TRANSPORTATION CABINET
DEPARTMENT OF HIGHWAYS
BOONE COUNTY, KY & DEARBORN COUNTY, IN
I-275 OVER OHIO RIVER
CARROLL LEE CROPPER BRIDGE
BRIDGE 008B00052N
SUPERSTRUCTURE REHABILITATION

1-53 As-Built
54-89 Shop-Plans
90-93 Addendum 5
94-95 Addendum 4
96-99 Addendum 3
100-102 Addendum 2
103-134 Addendum 1
134-258 Proposal
259-267 Questions-Answers
268-270 Bids

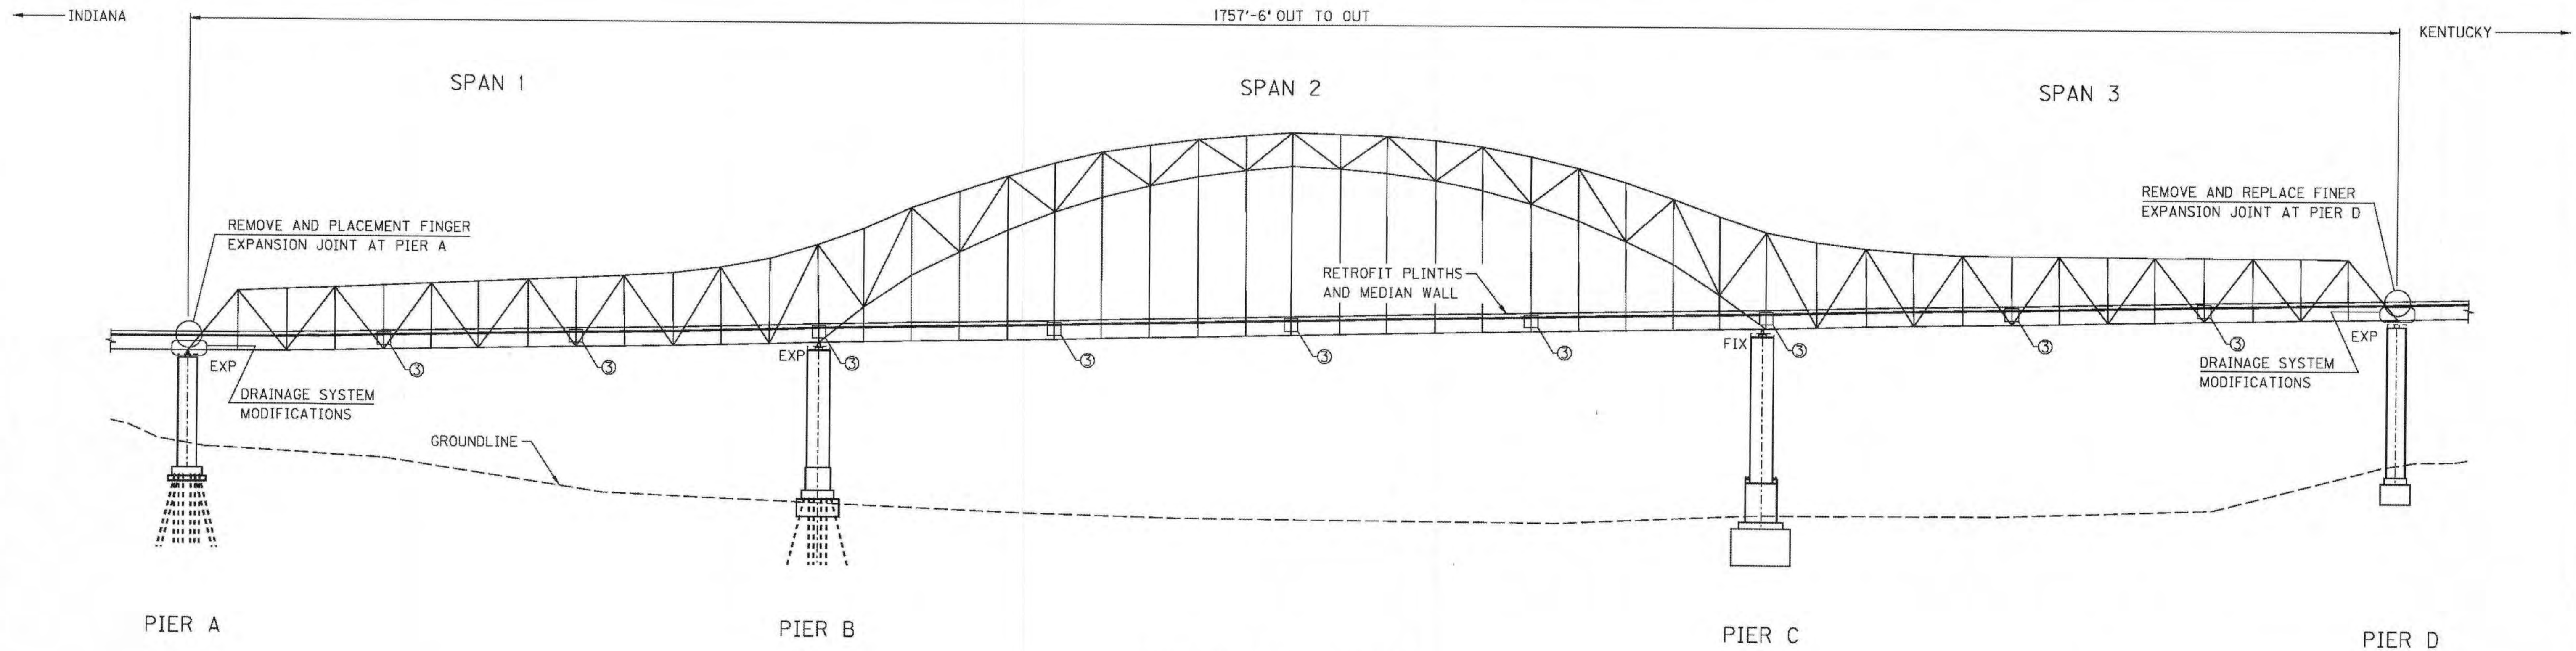
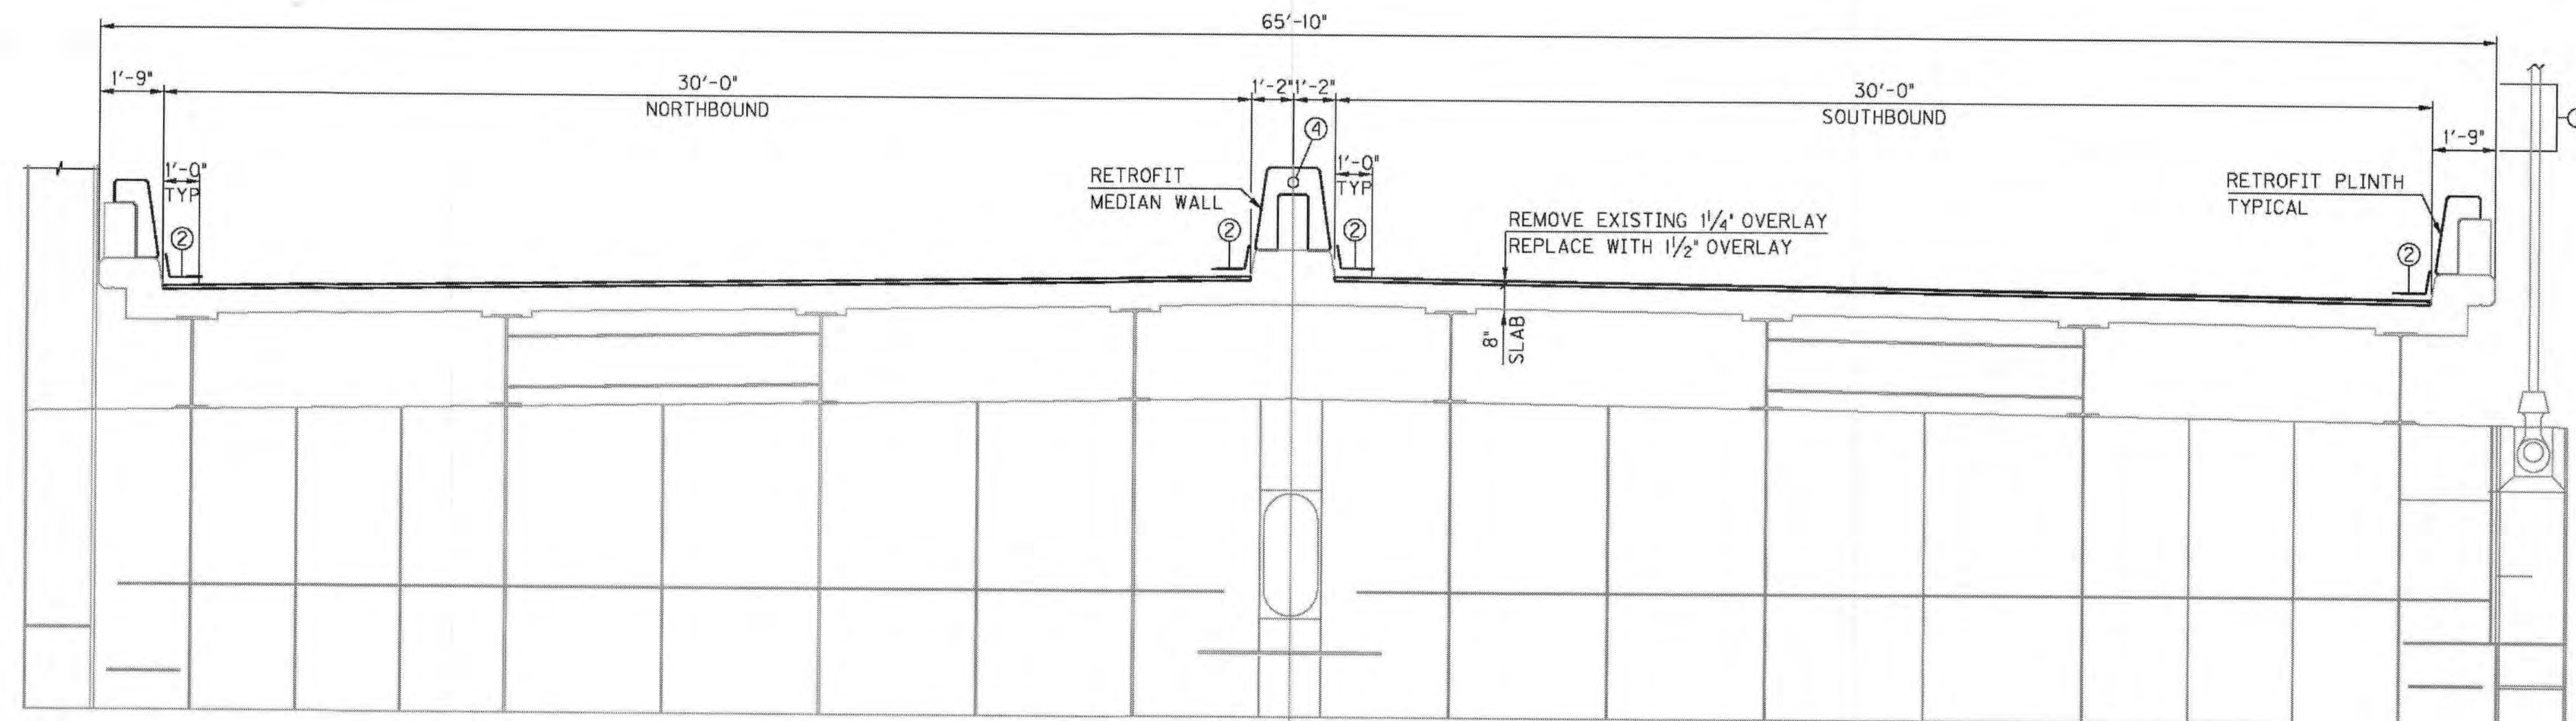
142980	100	Boone	Sheet S6 shows expansion joint replacement at piers A, B, C and D and at 7 locations between the piers. Sheet S12 shows joint replacement only at the piers. Are the joints between the piers to be replaced? If so, which details apply to the joints between piers A, B, C and D?	Pier A and D joints are detailed on sheets S19 – S22. Sheet S12 Notes specify, preformed expansion joint strip seal shall be D.S. Brown Company, L2-400 with SSPA Steelflex rail or approved equivalent. These will replace all 9 joints between Pier A and Pier D.	9/19/2014 10:49 AM
142980	100	Boone	It is typical that there is a Bid Item for the following Items that we do not see set up in the Bid Items Sheet. 08549 Blast Cleaning, 08510 REM Epoxy Bit Foreign Overlay OR 08551 Machine Prep of Slab Will these Items be added?	Yes, An addendum will be posted.	9/19/2014 10:49 AM
142980	100	Boone	In Section IV, Paragraph B. Calibration of the Special Note for	Yes, The minimum water usage listed in Section IV,	9/19/2014 10:49 AM
